Right School Right Place

Your ref: PL\0866\17

**Re: Proposed new 6FE school buildings and associated development at Land to the north of Lower Luton Road, Harpenden, Herts. ref: PL\0866\17.**

Visual Impact of selected School Buildings – approximation of illustrative assessment relative to applicant defined plan sections.

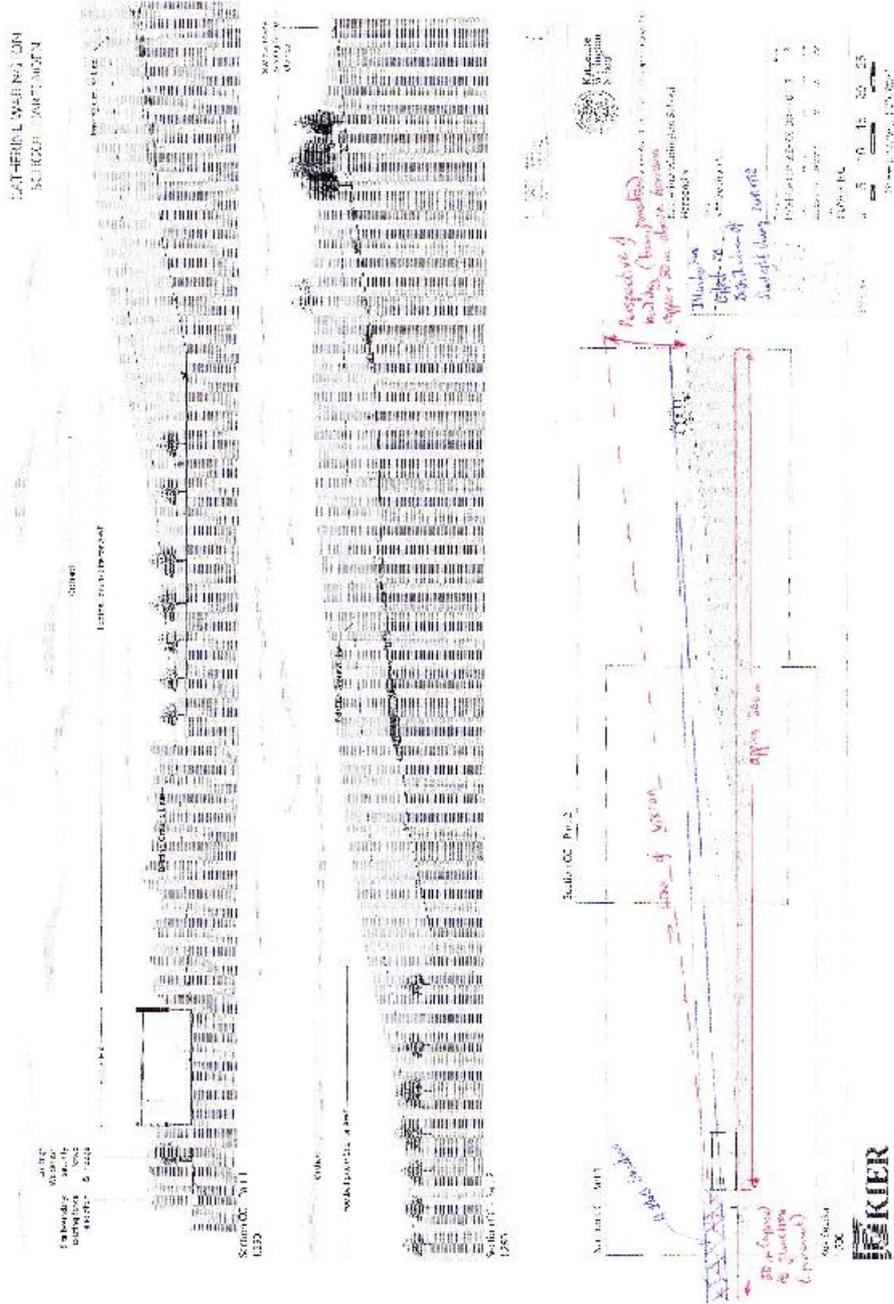
- The greatest failure of consideration of residential amenity comes from the lack of LViA assessment. As noted in previous representations the assessment provided references guidelines for derivation of 'worst case' situations through an Appendix which is not provided. Assessments therefore cannot be cross referenced against the process that the

assessors claim to have followed. What is apparent is that highly selective views have been presented which miss impact of site generally over a large area – notably from all housing on Southern slopes of River Lea, particularly on Crabtree Lane and its tributary roads from Aldwickbury to Marquis Lane. However major impact of the Sports Hall on the Eastern side of Batford estate is effectively ignored. The exit from the estate on Milford Hill will be dominated by an overshadowing building that will literally eclipse a number of homes, roads and pavement. The dimensions and appearance of the Sports Hall received little commentary in the emerging plans – in contrast to the main building. Subsequent addition of clearer contour data (dated 15-12-2017 in a separately identified Further Information folder) allows for rudimentary assessment of the impact of the building. This appears to show a building of a mainly bland monotonous finish (along over 70% of its length) standing on a base of at approx. 93.5m with an indicative height of 10.5m (the elevations are imprecise with marked heights not corresponding to plan definitions). The added information indicates a level of 95.0m in a residential garden on North Western corner of Milford Hill / Common Lane junction. This is estimated to be at least 0.5m above the level of the road junction. From this level a 10.5m ‘wall’ has the appearance (in perspective) of a solid wall equivalent to 50m above the horizon. This equates to 4 times the current rise in land level. From points close to the current field boundary (such as presented to drivers exiting Milford Hill) the width of the building will have the appearance of extending over half of the entire Eastern boundary length. In essence the view is totally dominated by the building, a building for which the only break in the monotony of finish is some second storey windows at Southern End which will effectively look directly in to second storey windows of houses in Common Lane – a condition Vincent & Gorbing stated was to be avoided in initial searches. More relevant however is the effect on sunlight reaching the properties and roads on western boundary of the site. The sunrise in the area takes place along the eastern boundary of the site (varying in where the sun appears during course of year, but in winter effectively due east). Using Section line C in clarified landscape plan a rising sun at point C2 currently casts fails to light the road at the junction for 30-45 minutes due to the roadside tree/hedge line – the initial shadow (which is imprecise due to nature of vegetation) appears on Milford Hill near Tallents Crescent junction. (This is a little under 100m that would be cast as a shadow if Milford Hill were level – the rise reduces it). With the addition of the Sports Hall a taller and more defined block to light would be present – in level conditions this is estimated to generate a shadow length stretching to approximately 250m compared to 100m beyond the junction. This would stretch well beyond Tallents Crescent junction and would fall on numerous properties. The width of the shadow – given the chosen orientation of the proposed Sports Hall is substantial – for roads and properties closer to the build line (within say 100m) it is likely that the shadow will persist for 45-60 minutes longer at certain times of the year and that the path of the rising sun will mean some areas are completely denied direct sunlight for parts or even all of the year. In particular the

footpath down Milford Hill (South Side) turning into Common Lane (west side) will see critical periods of the year where no direct sunlight will assist in frost / ice / snow clearance – this is the main walkway for people walking to the eastern section of the Batford Estate, including pedestrian traffic to / from Batford Nursery / Children’s Centre / Sauncey Wood Primary School. For residents in most affected properties (facing the sports hall) the view from ground floor windows will be totally dominated by the building (no visible sky from points within building) and from second storey there will be severely restricted views. Consideration of main school building suggests that although lower in overall height, properties and the road that are within 50-60m of the build line will also experience significant loss of view and light – Appendix 3 indicates the spread of areas affected (which in some cases will extend beyond the area shown on plan. The calculations are approximate, that there was no attempt to consider them in the drawing up of the plan is unacceptable. The plan preparation should have incorporated evaluation of impact in a manner that clearly identifies both loss of light and visual impact. It is considered such work is essential before plans are considered and the plans should be rejected until such matters are addressed. It is further considered that marker balloons are used to identify building corners and that the presentation of these is made known to interested parties given the applicant’s reluctance to properly address such matters. It is further noted that a number of options for the Sports Hall location were considered before settling on a solution that maximized loss of amenity for local residents, reinforcing the view that such considerations have not been taken into account by the applicant.
